GLEN AT WIDEFIELD FILING NO. 9
SPRING GLEN DRIVE (Sta. 30+00 to Sta. 43+00)
PLAN AND PROFILE
EL PASO COUNTY, COLORADO

Project No.:	17038
Date:	September 25, 2018
Design:	AWMc
Drawn:	JAK
Check:	AWMc
Revisions:	
	Δ 4/16/19 Profile/San. Sewer

**GLEN AT WIDEFIELD FILING NO. 9
BITTERCRESS PLACE (Sta. 0+00 to Sta. 9+00)
PLAN AND PROFILE
EL PASO COUNTY, COLORADO**

CUL-DE-SAC PROFILE

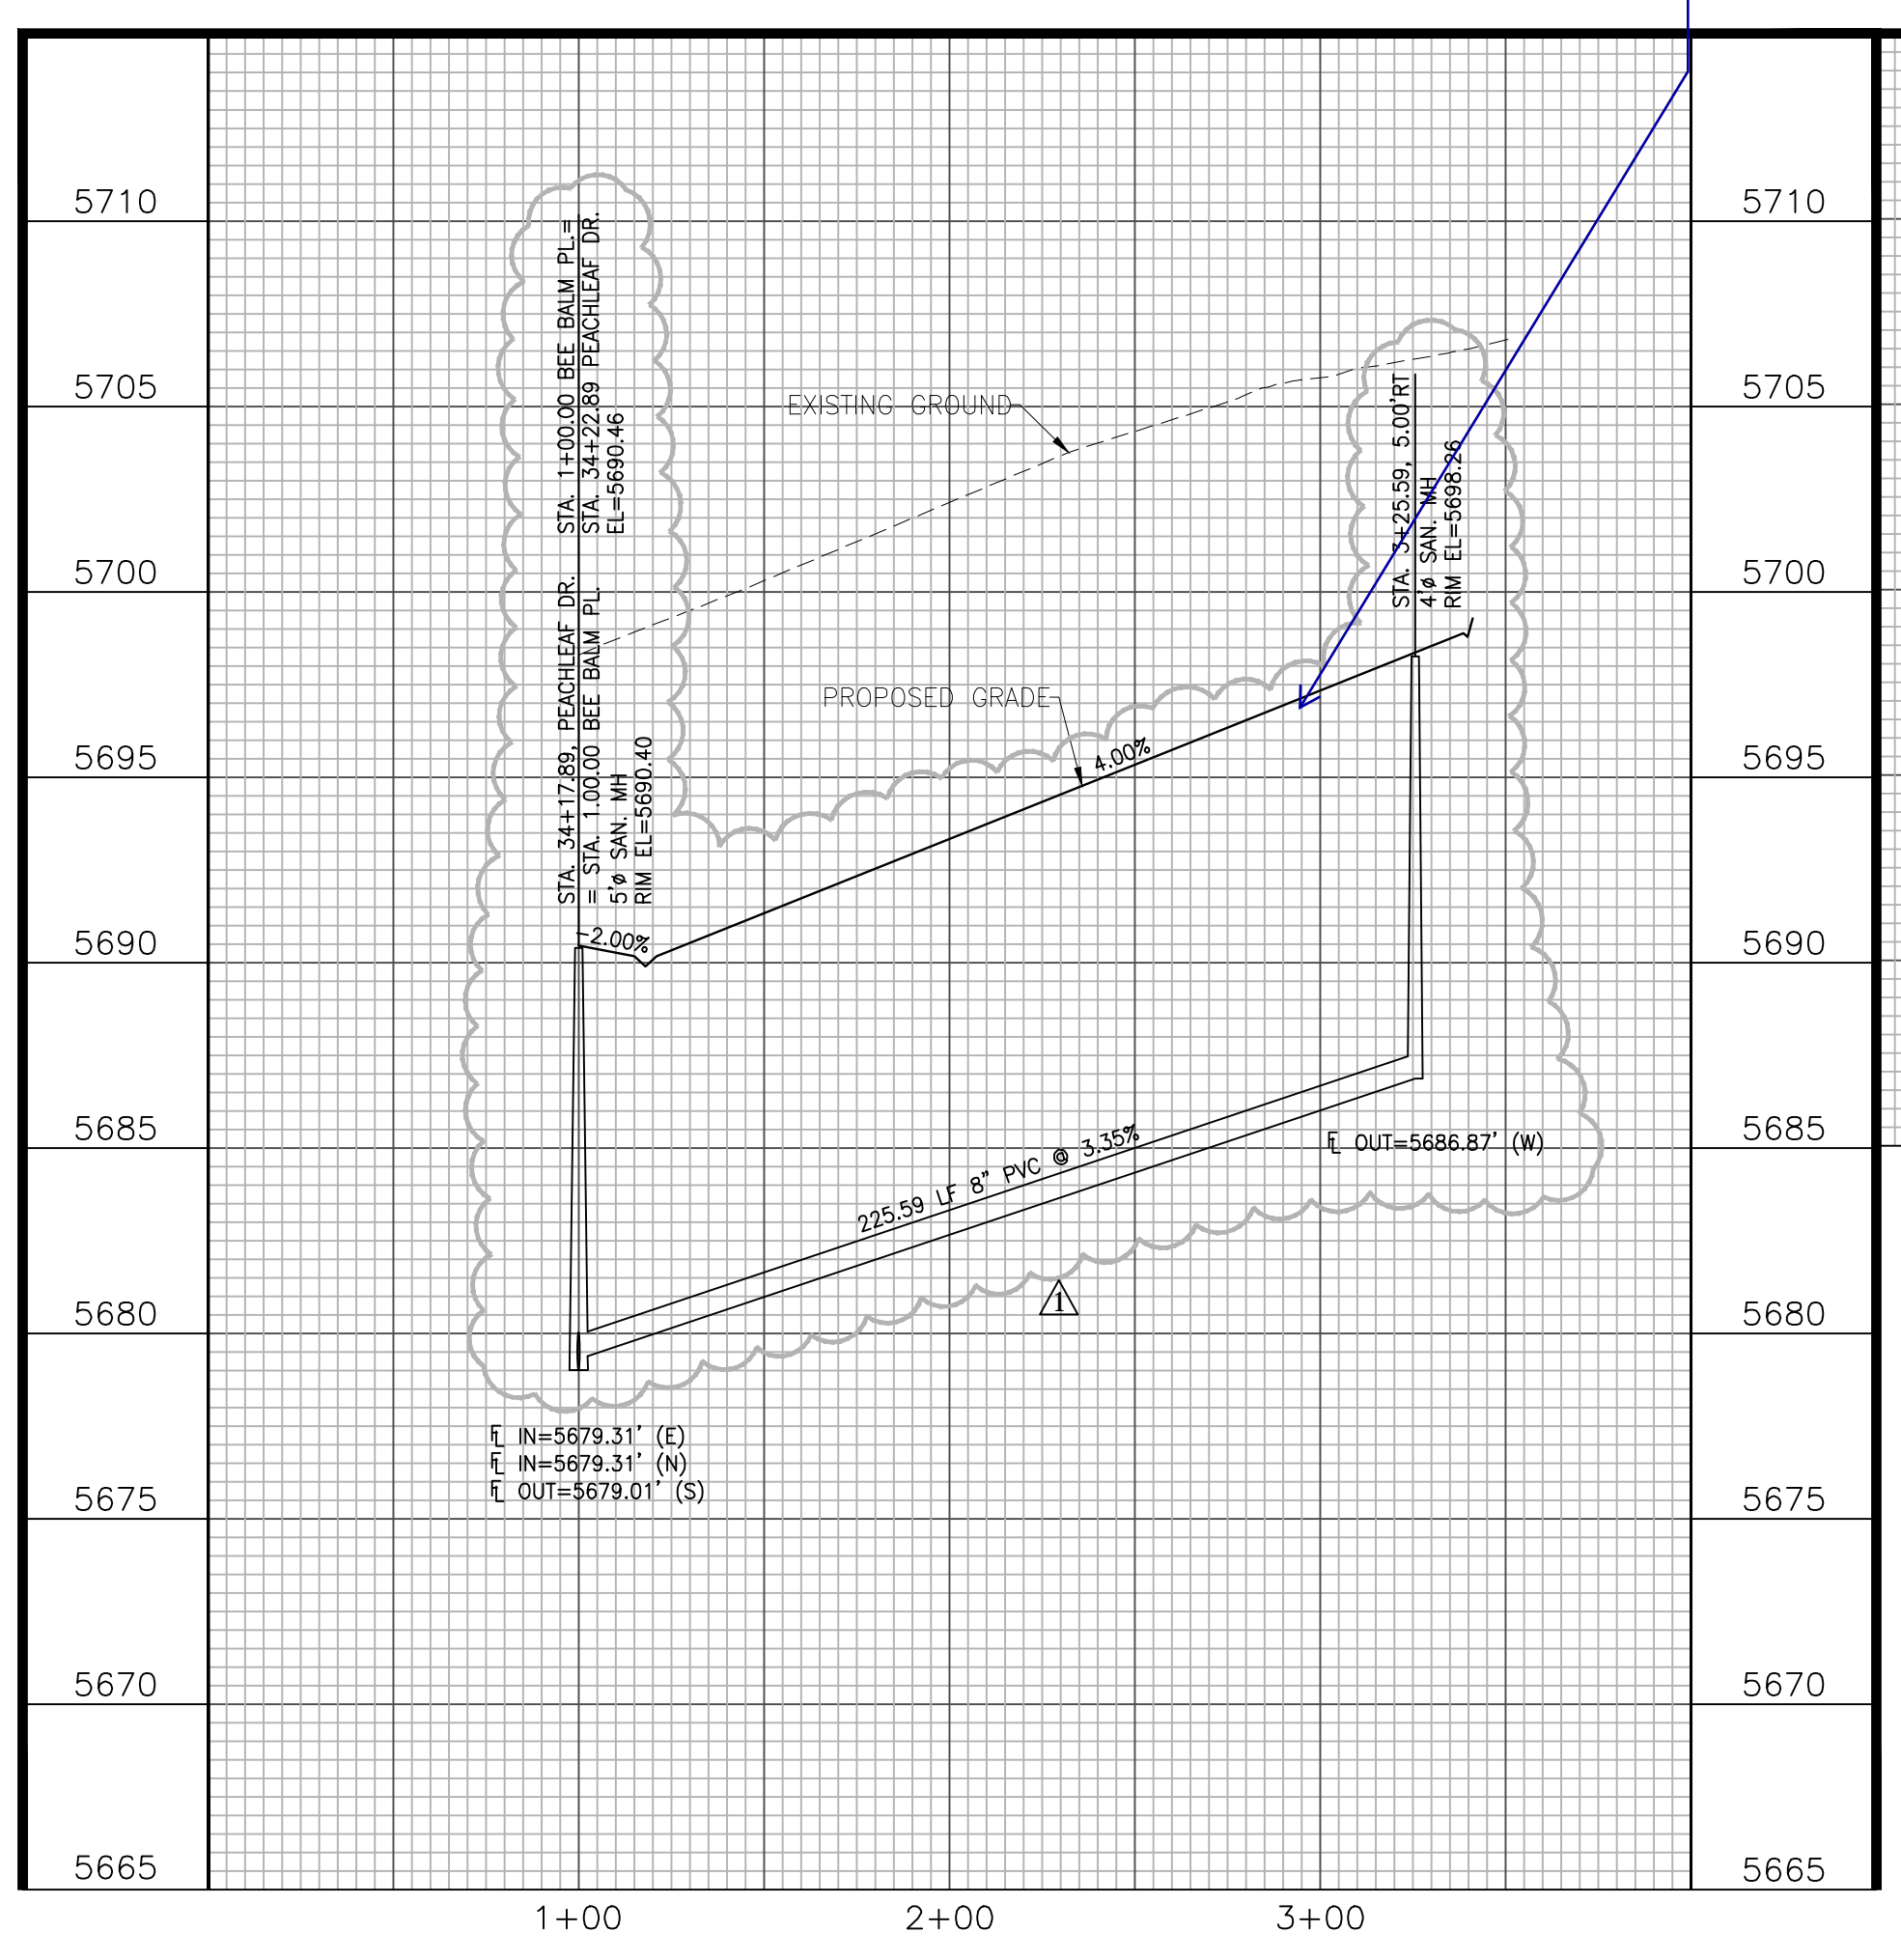
Revise profile. Cross slope of the pedestrian access path must meet ADA criteria of 2% max.

Revise centerline profile grade within the cul-de-sac bulb to 3.0% max. See ECM Section 2.3.8 Figure 2-31.

STOP SIGN R1-1
SCALE: 1/4"=1'-0"

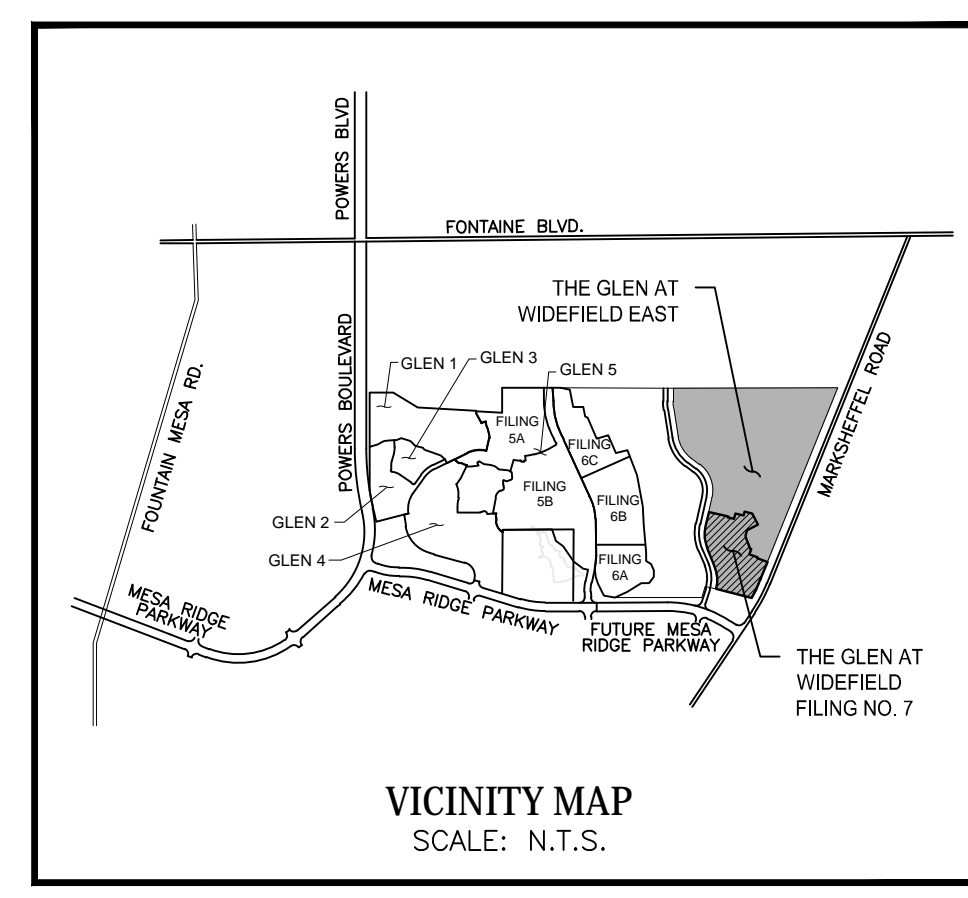
See detail this sheet for additional speed limit signage required on Spring Glen north of Mesa Ridge Parkway.

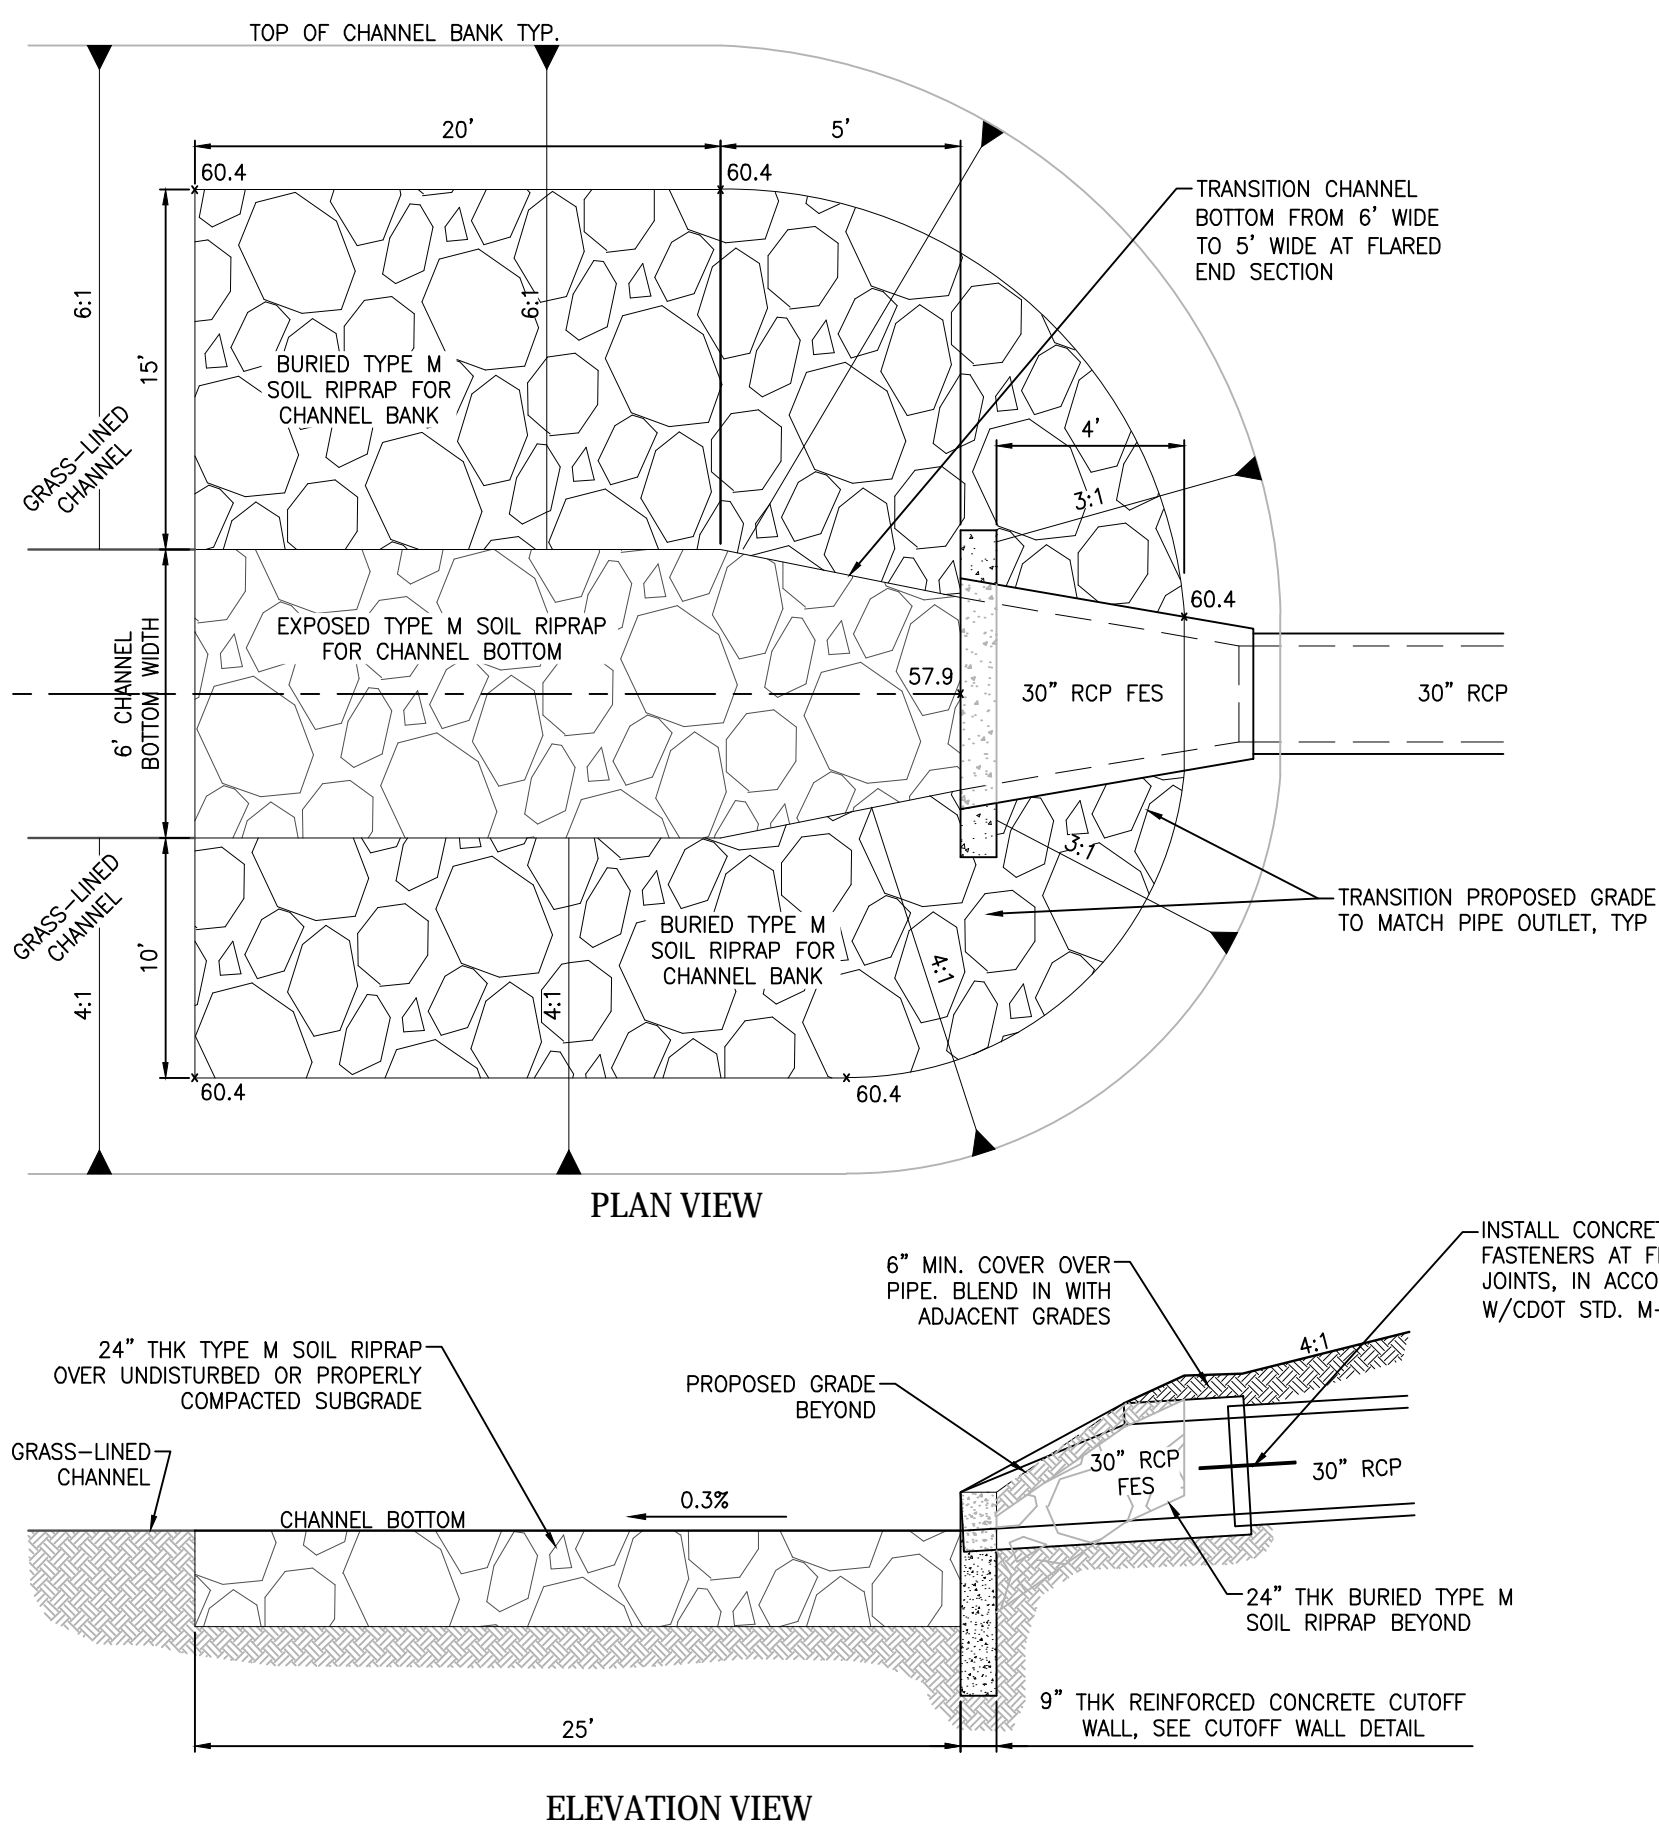
Adjust the emergency spillway elevations. The grading plan shows a top of embankment elevation = 72.0.
